Office Action Summary

10/773,346

JAEGER, JOHN C.

DETAILED ACTION

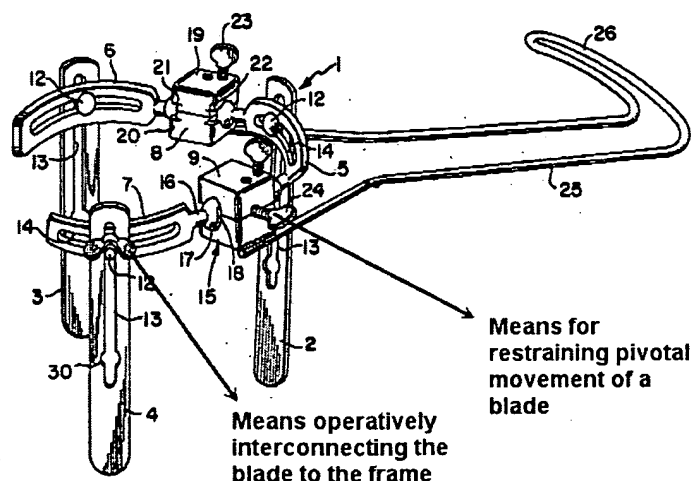
Karlin et al. disclose a retractor including: a support frame (defined by support members 5, 6, 7); at least three blades (2, 3, 4); means operatively connecting each blade to the frame; and means for restraining the pivotal movement of a blade (Fig. 1, col. 2, lines 55-72, cols. 3-4 and col. 5, lines 1-53). See marked up Fig. 1 from Karlin et al. below.

Regarding claim 10, Karlin et al. disclose a plurality of blocks 8 and 9, each of which interact with a respective end section of a respective blade by means of members 5, 6 and 7.

Applicant's arguments with respect to the rejections of claims 1-2, 4-5, 8, 10, 15-17, 23, 26 and 31 as being anticipated by Karlin et al. are not persuasive because Karlin et al. disclose all elements of Applicant's claimed invention.

The Examiner notes that "pivotally connected" only requires the blades to have the capability to pivot or angulate with respect to the arcuate members 5, 6 and 7 defining the support frame. When the wing nuts are not completely tightened, the blades angulate with respect to the frame and are therefore pivotally connected to the frame. Also, when the wing nuts are not completely tightened, the blades are capable of moving into engagement with one another (see Fig. 2).
